Modification Recommended Service Note

P5003A Keysight Streamline USB Vector Network Analyzer

Serial Numbers: From MY58100696 to MY58100732

Potential lifted front panel overlay

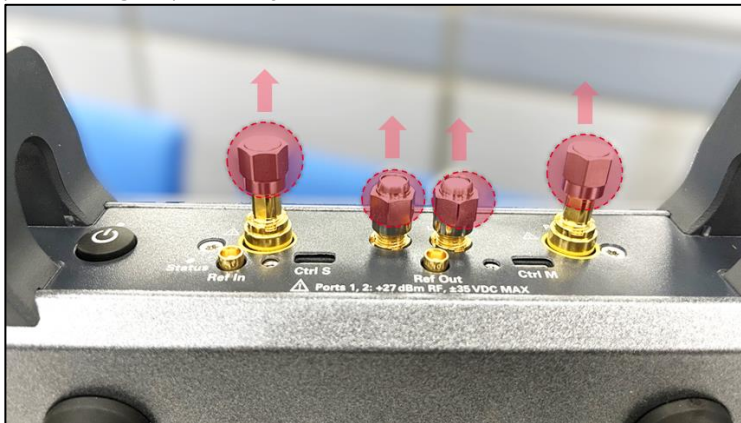
Keysight streamline series vector network analyzer (VNA) of serial number range identified in service note cover page might potentially exhibit the following lifted front panel overlay symptom.

Apart from cosmetic imperfections, the lifted front overlay could have led to non-fully attached *Ctrl S* micro-HDMI cable connector in multi-VNAs setup configuration.

-> Apply this service note only if end users' VNA is exhibiting the following symptom.

Procedure to replace the front panel overlay.

1. Remove the front handles. Detach the 50-ohm termination (LO-In, LO-Out, Port 1 & Port 2) or protecting caps if they are attached to the VNA.

2. Pry open the existing front panel overlay and remove it from front panel.
3. Clean the metal surface thoroughly and ensure it is free of adhesive residue.
4. Affix the new self-adhesive front panel overlay onto the metal surface.
5. Reinstall (reuse) the 50-ohm terminations or protecting caps accordingly.

6. Reinstall (reuse) the front handles.
